# Addendum

**PROJECT:** Office Renovation and Addition for  
City of Huber Heights Tax, Finance & Water Departments

## **ADDENDUM NO. 2**

**E1.1**

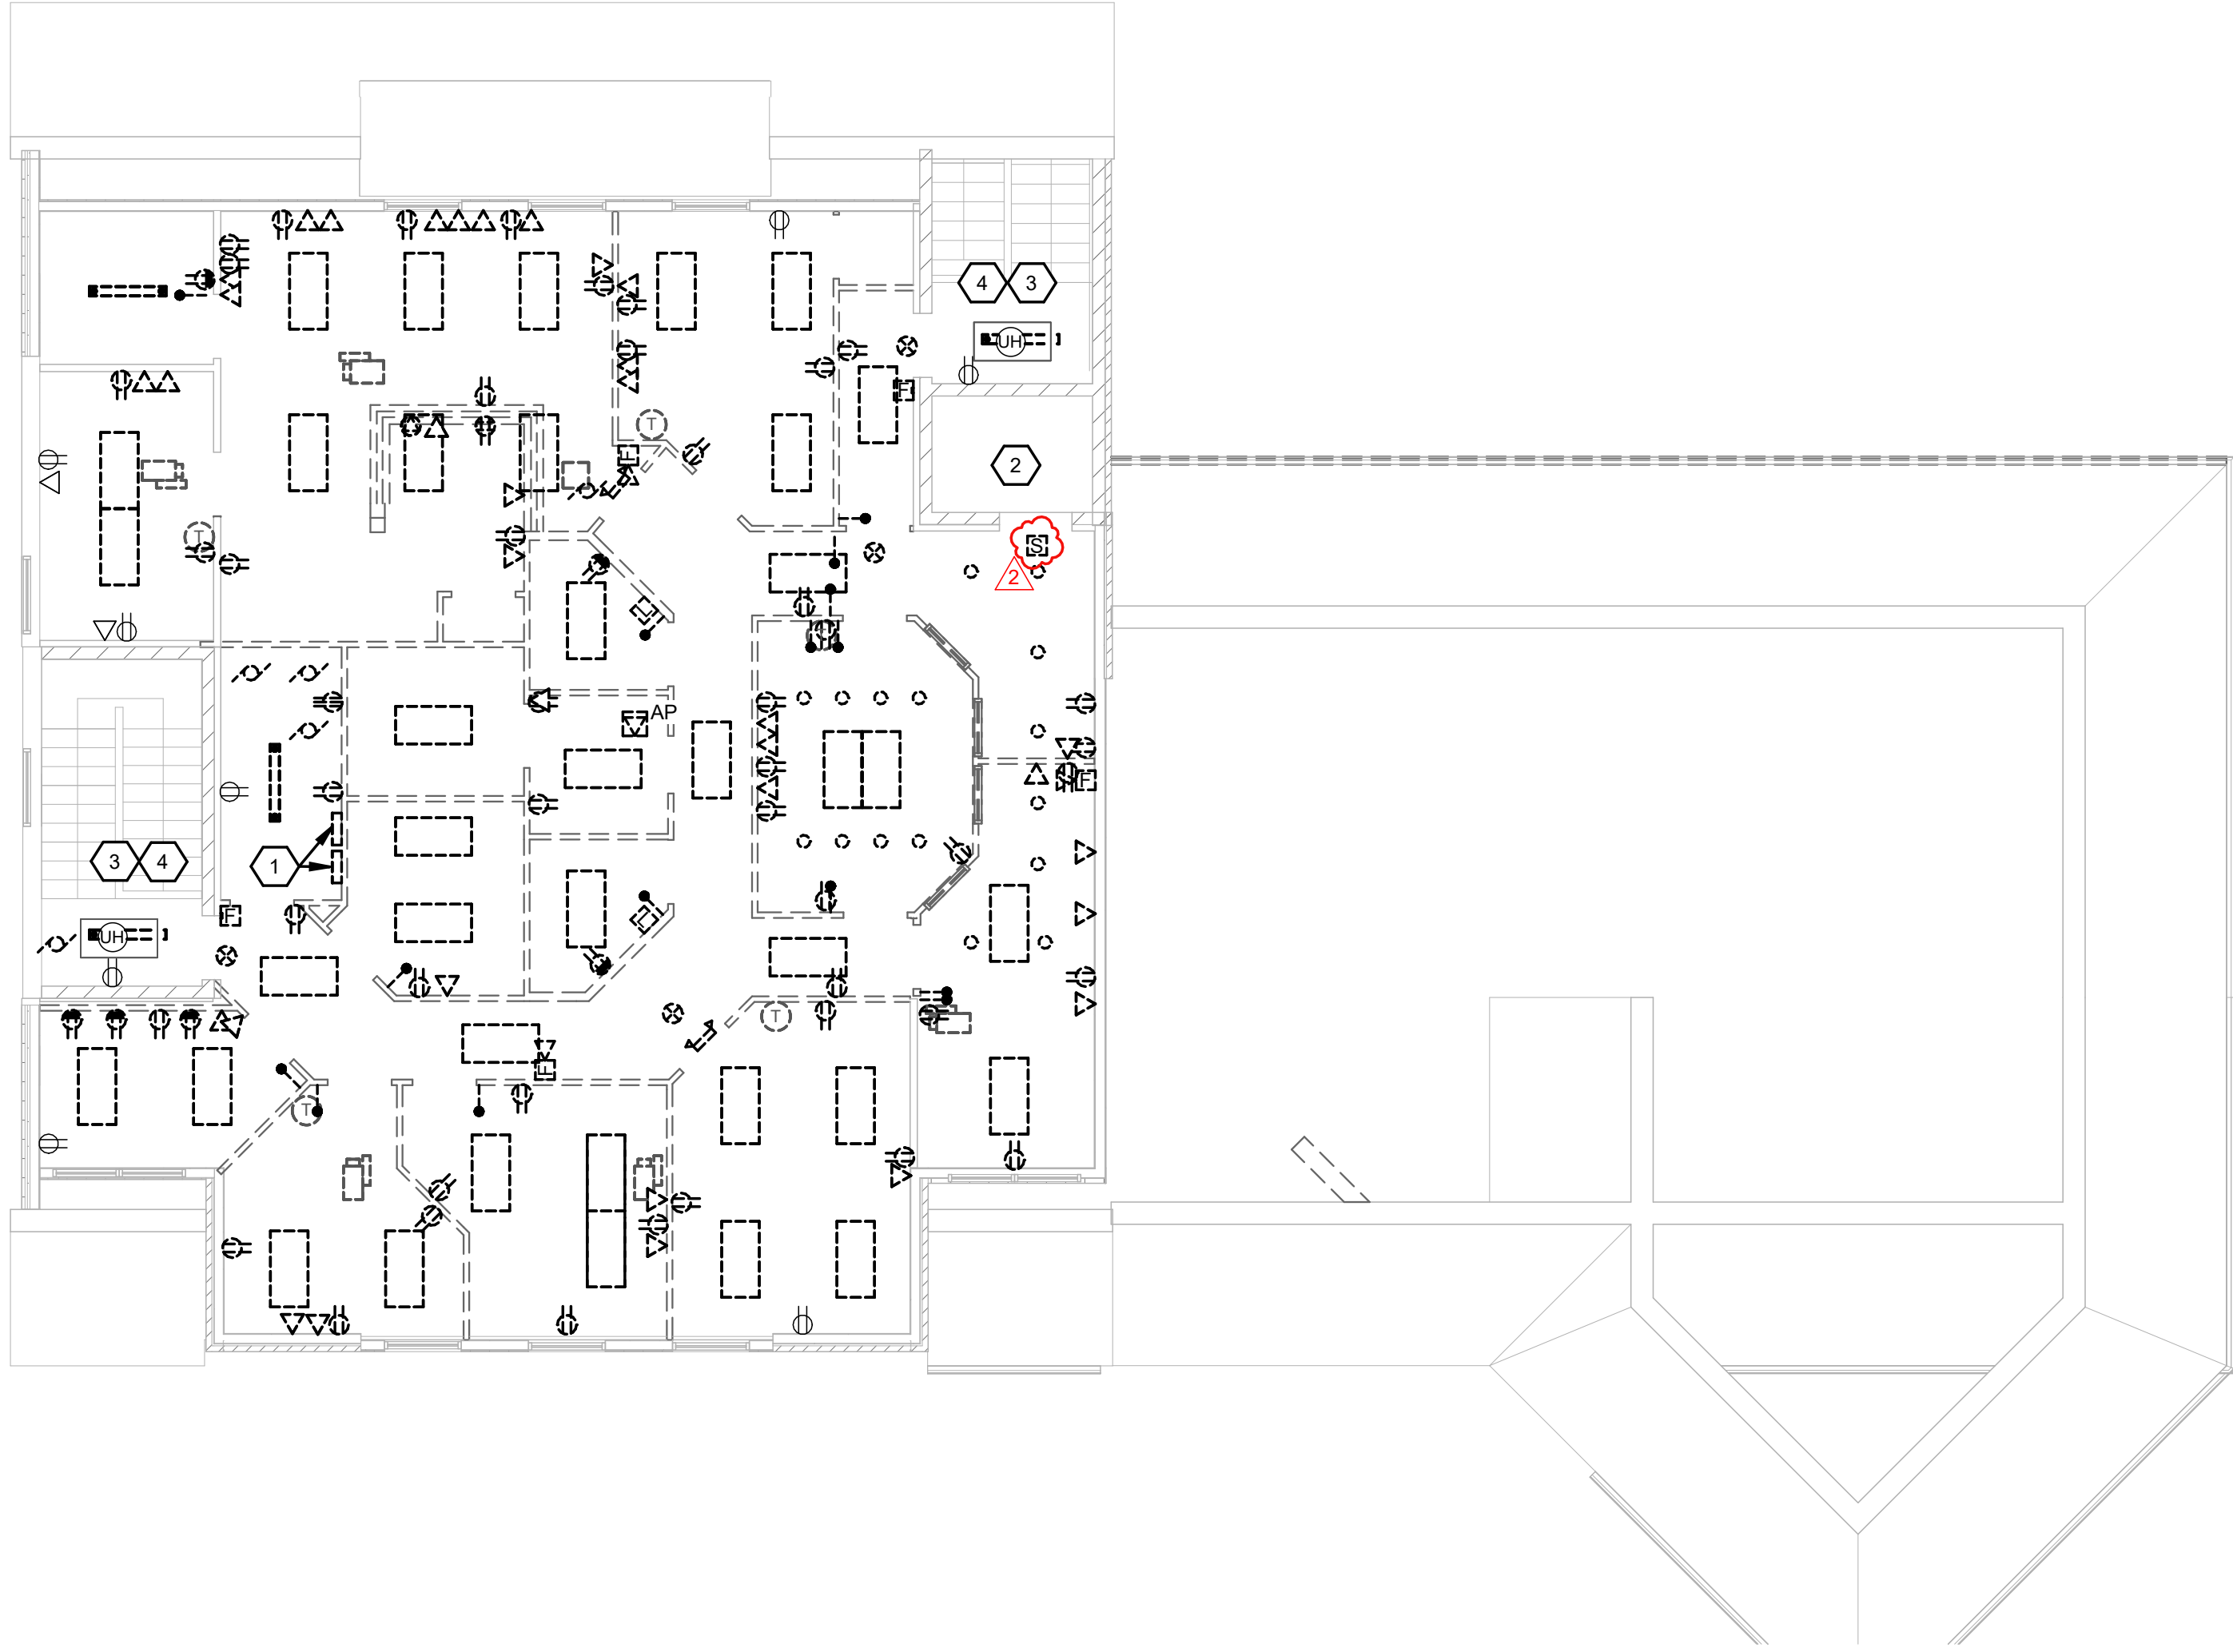
ITEM E1 DRAWING, E1.1, E1.2  
1. Modify notes to reflect changes to fire alarm system.  
2. Remove existing smoke alarms.

3. RETAIN EXISTING POWER/CONVENIENCE RECEPTACLES IN ELECTRIC SERVICE ROOM. DISCONNECT POWER TO AIR HANDLING UNITS TO ACCOMMODATE REMOVAL BY OTHERS.
4. RETAIN ALL ELEVATOR POWER, CAB LIGHTING AND ASSOCIATED ELEVATOR POWER CONTROLS AND FIRE ALARM FOR ELEVATOR MACHINE ROOM AND ELEVATOR CAB DURING COURSE OF CONSTRUCTION. REPLACE EXISTING DEVICES ONCE NEW FIRE ALARM SYSTEM IS ESTABLISHED.

5. DISCONNECT AND REMOVE POWER FROM OUTDOOR A/C UNITS, ASSOCIATED DISCONNECTS, ETC. BACK TO MAIN SERVICE SWITCHBOARD.
6. EXISTING FIRE ALARM PANEL TO REMAIN ACTIVE DURING CONSTRUCTION.

8. RETAIN CIRCUITRY TO EXISTING UNIT HEATERS IN STAIR WELL.
9. REMOVE EXISTING FIRE ALARM ANNUNCIATOR. REFER TO SHEET E4.1 FOR LOCATION OF NEW.

**E4.1**

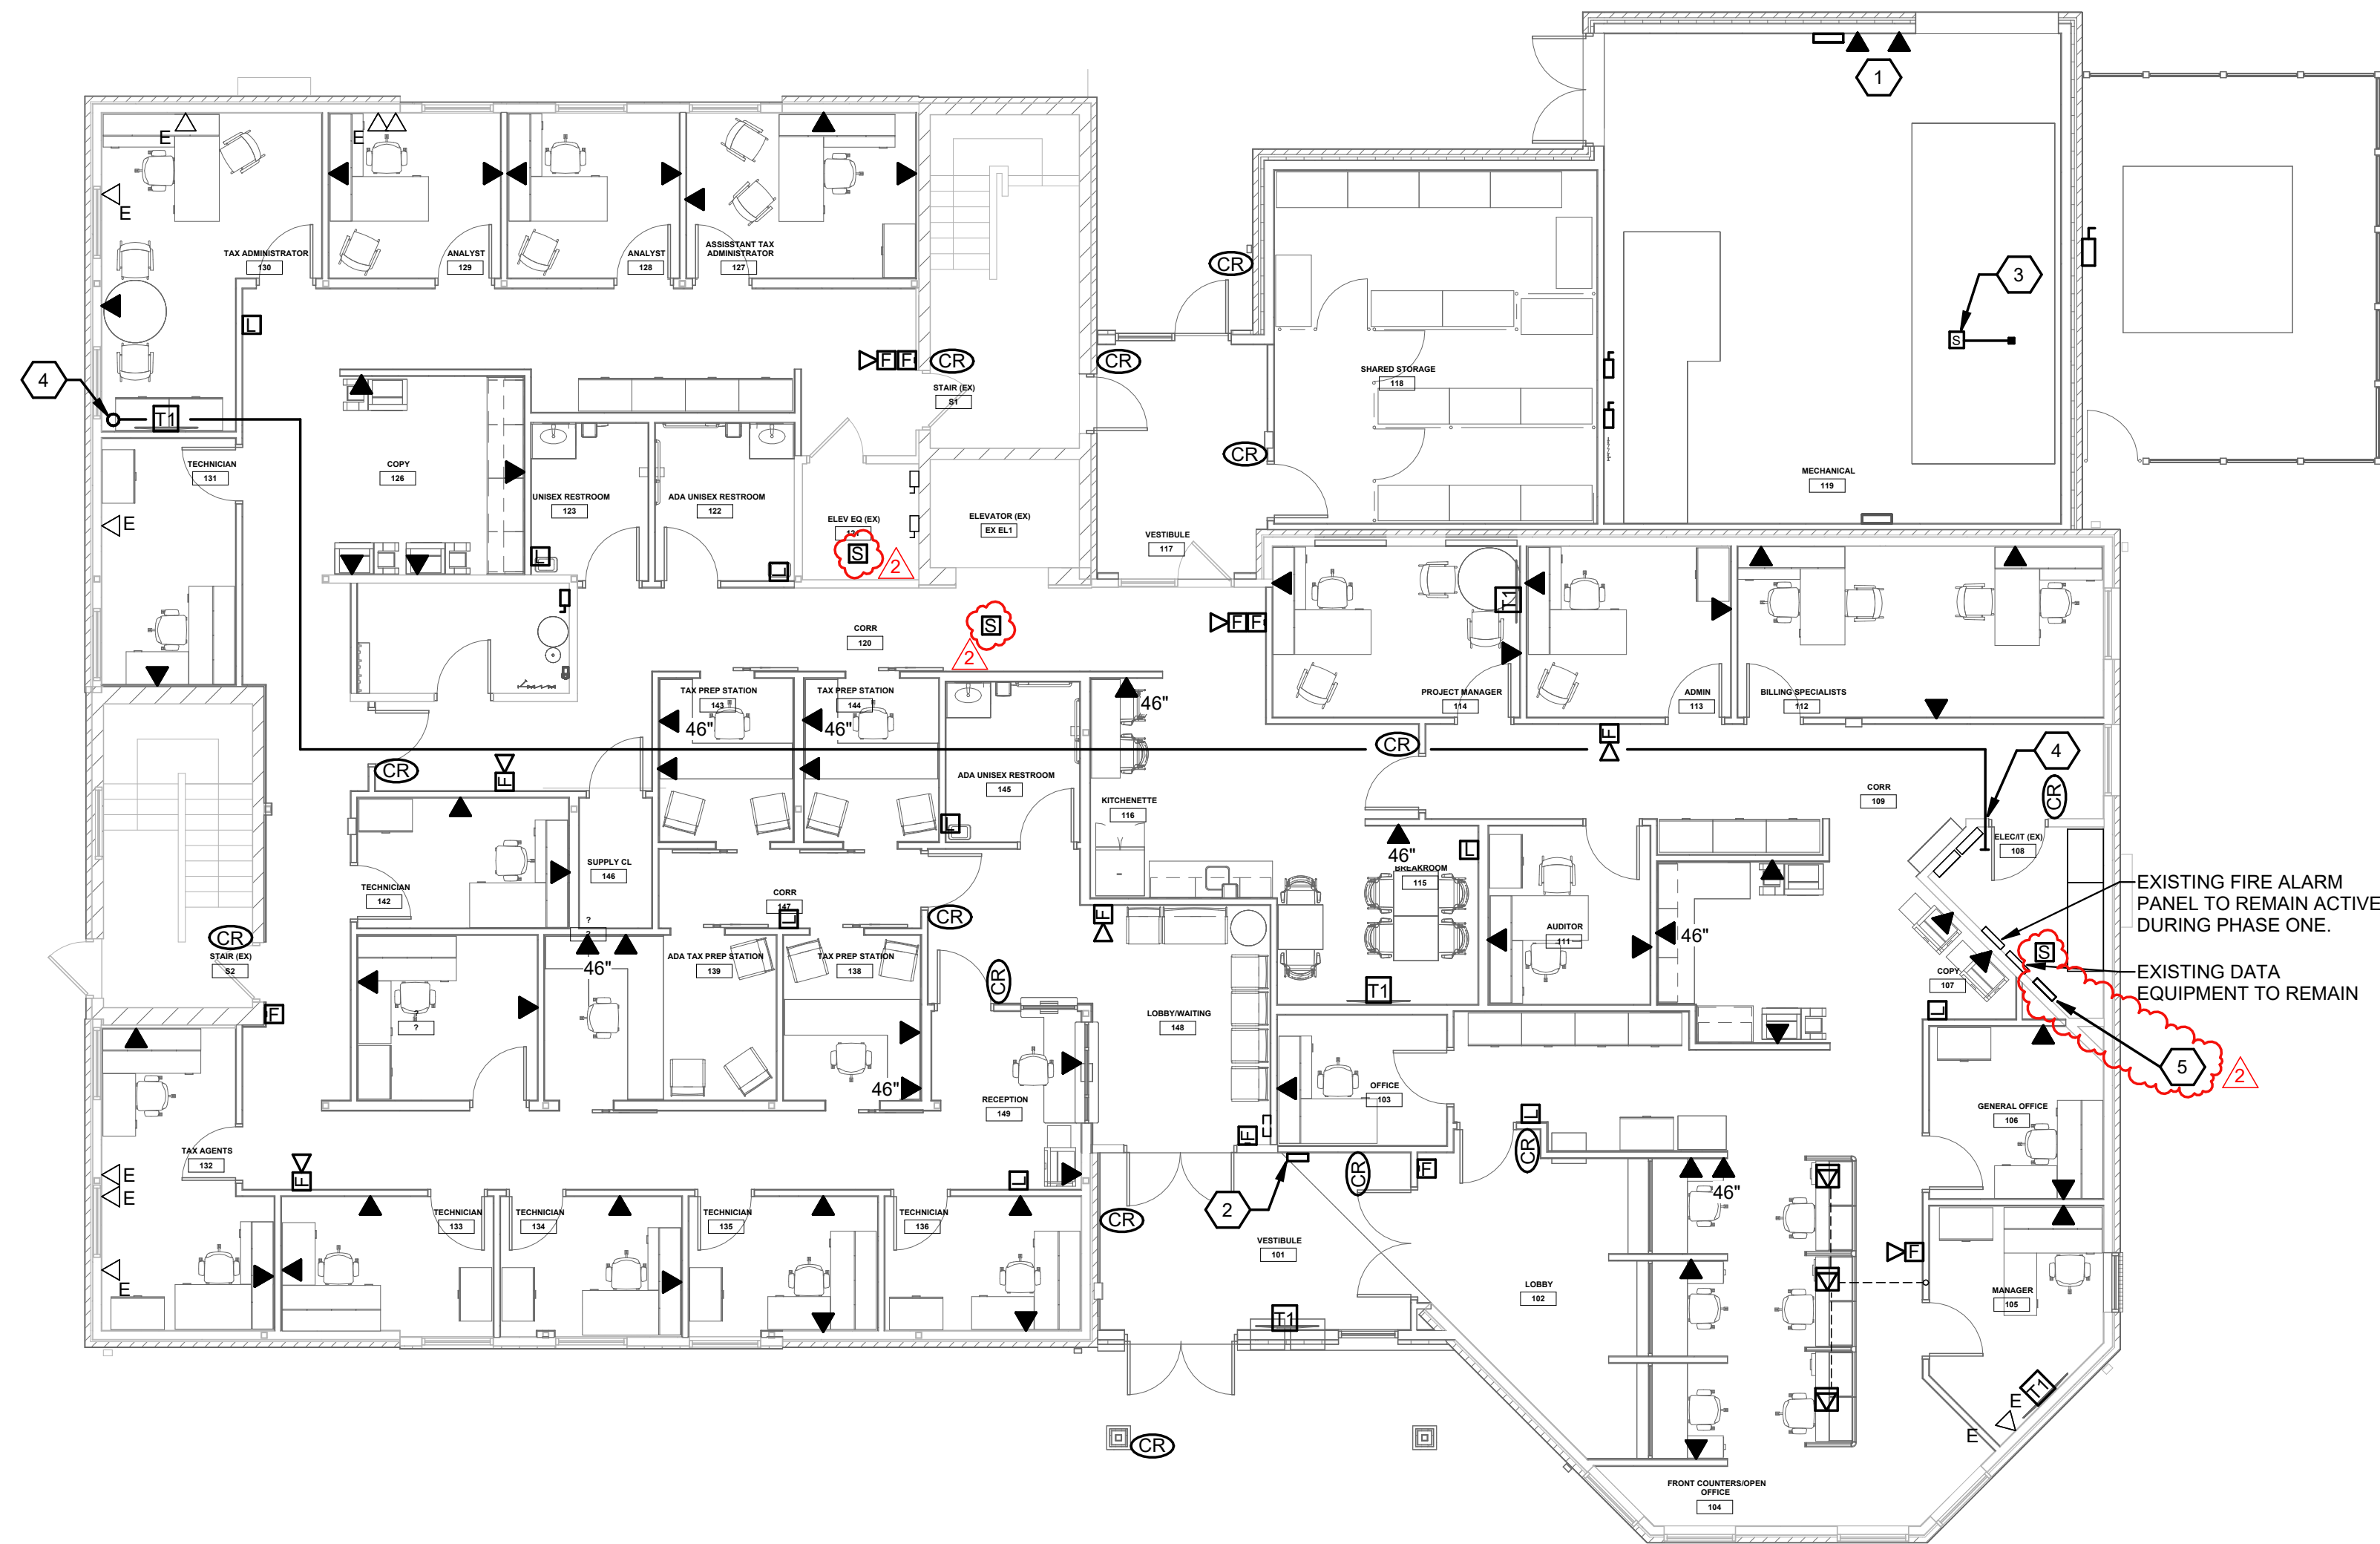
ITEM E2 DRAWING, E4.1  
1. New smoke detectors, and annunciator panel  
2. Modify note to reflect changes to fire alarm system.

1. PROVIDE TWO WALL BOXES MOUNTED AT 46" M.H. FOR DATA CONNECTION TO HVAC CONTROL PANELS.
2. LOCATION OF NEW FIRE ALARM ANNUNCIATOR PANEL.
3. SMOKE DETECTOR LOCATED IN RETURN AIR DUCT, COORDINATE LOCATION WITH H.C.
4. PROVIDE 4" CONDUIT (WITH PULLSTRING) ABOVE ACCESSIBLE CEILING FROM EXISTING FIRST FLOOR DATA OVER TO BELOW NEW SECOND FLOOR DATA CLOSET AND UP THROUGH THE FLOOR.
5. NEW FIRE ALARM PANEL.
